Work Order ID 142268

DART SERVICE INSTRUCTION

TO AMEND INSTALLATION INSTRUCTIONS D350-607-3 Rev.D,
INSTALLATION INSTRUCTIONS D350-607-4 Rev. C AND
INSTRUCTIONS FOR CONTINUED AIRWORTHINESS ICA-D350-607 REV. 6

REF TCCA STC: SH94-14
REF FAA STC: SR00213NY
REF EASA STC: EASA.10016996
REF BRAZILIAN STC: 2007S03-03/04/05/06

FIGURE 1: INSTALLATION OF D4775-041 FWD STRUT

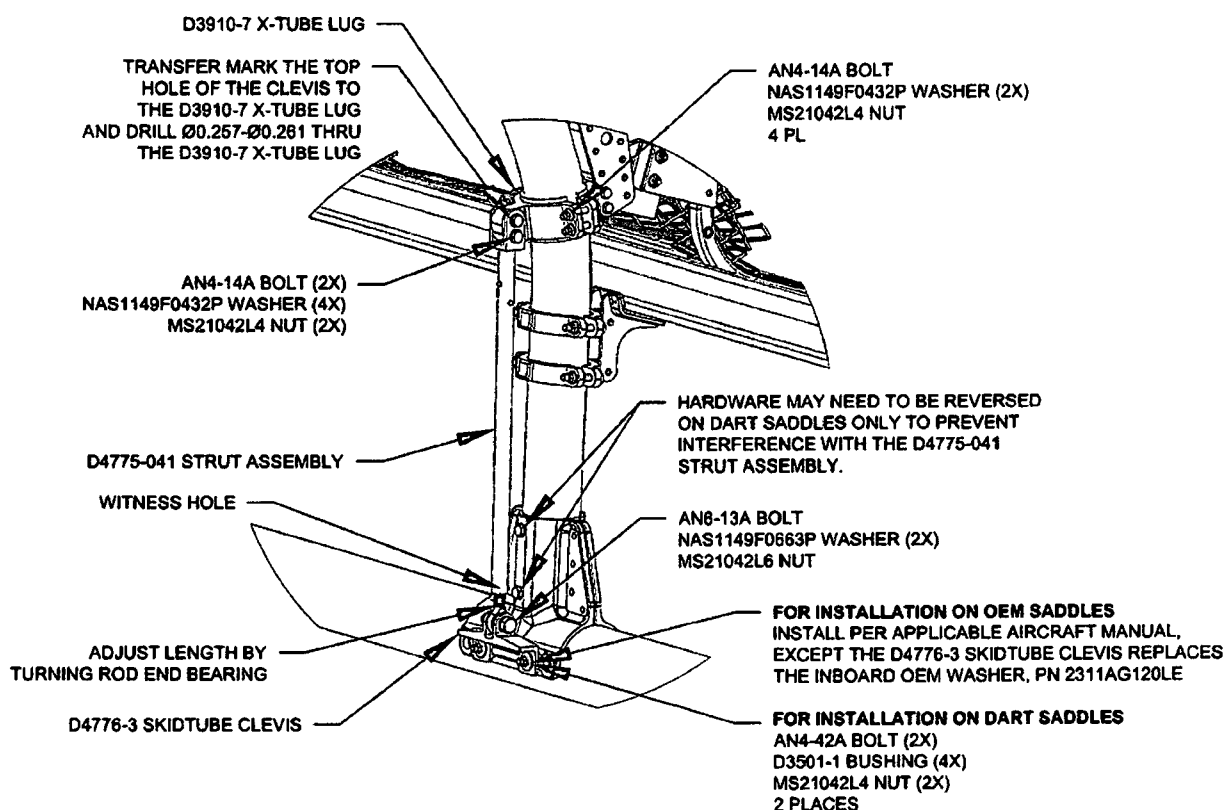
3.1 Substitute the Forward Lower D3910-5 X-Tube Lug with the D3910-7 X-Tube Lug as shown in Figure 1.

3.2 Install the forward D4775-041 Strut Assembly. Transfer mark from the upper hole on the clevis of the D4775-041 Strut Assembly to the D3910-7 X-tube Lug and drill thru the lug $\varnothing 0.257$ - $\varnothing 0.261$ as shown in Figure 1. Touch up chemical conversion coating per MIL-DTL-5541. Check the witness holes located at the bottom end of the D4775-041 Strut Assemblies to ensure that the thread from the rod end extends past the witness hole.
Torque MS21042L4/-4 nuts to 50-70 in-lbs (5.7-7.9 N-m). Torque MS21042L6/-6 nuts to 160-190 in-lbs (18.1-21.5 N-m).
